STAFF REPORT

THE CORPORATION OF THE TOWN OF COBOURG

Report to:	Mayor and Council Members	Priority:	<input type="checkbox"/> High <input checked="" type="checkbox"/> Low
Submitted by:	Dave Johnson Planner II – Heritage Planning and Development Planning djohnson@cobourg.ca	Meeting Type:	Open Session <input checked="" type="checkbox"/> Closed Session <input type="checkbox"/>
Meeting Date:	November 3, 2021		
Report No.:	HP-2021-033		
Submit comments to Council

Subject/Title: Heritage Permit Application – 36 King St W -Roof Replacement (South Portion of the Roof Only) – Luu

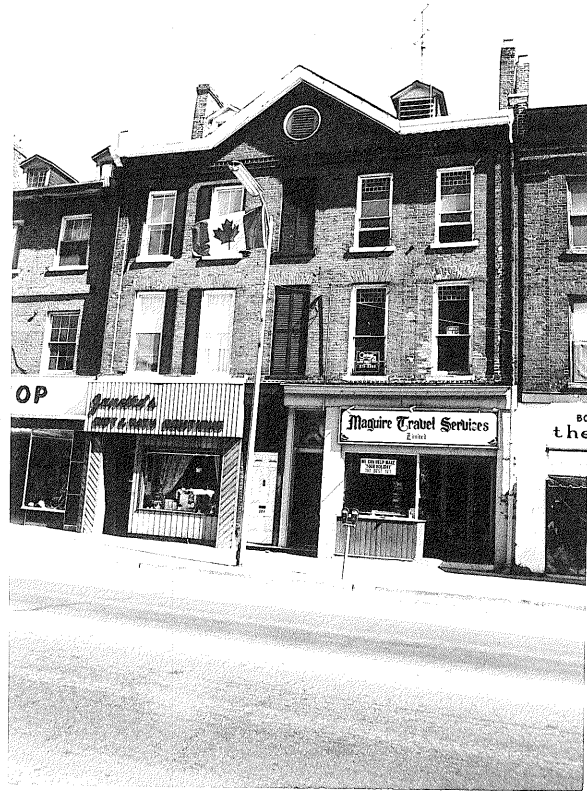
The property owner of 36 King Street West proposes to replace the aging asphalt roof with a black metal roof similar in design to other metal roof replacements on commercial buildings on King Street. The owner is proposing metal in order to add a protective element to the roof, more resilient to environmental elements that adds a protective and durable layer for many years to come, and to match the existing north facing steel roof. The property owner notes that the current roof is ageing and is in poor shape. There will also be ultra-low profile vents added to the ridge line.

The proposed alteration has been evaluated against the Commercial Core HCD Plan, specifically the policy relating to roofs (4.3), and it has been determined that the new roof (change from asphalt to black metal) is an acceptable/sympathetic alteration. The roofline, dormers, chimneys, and other defined heritage attributes are not proposed to be changed as a result of this alteration. The applicants have retained Moffat Bros. as the contractor to undertake the proposed alteration.

FURTHER THAT Heritage Permit Application HP-2021-033, submitted by Michael Luu – be approved to permit a roof replacement at 36 King Street West, subject to the finalization of details by Heritage and Planning staff.
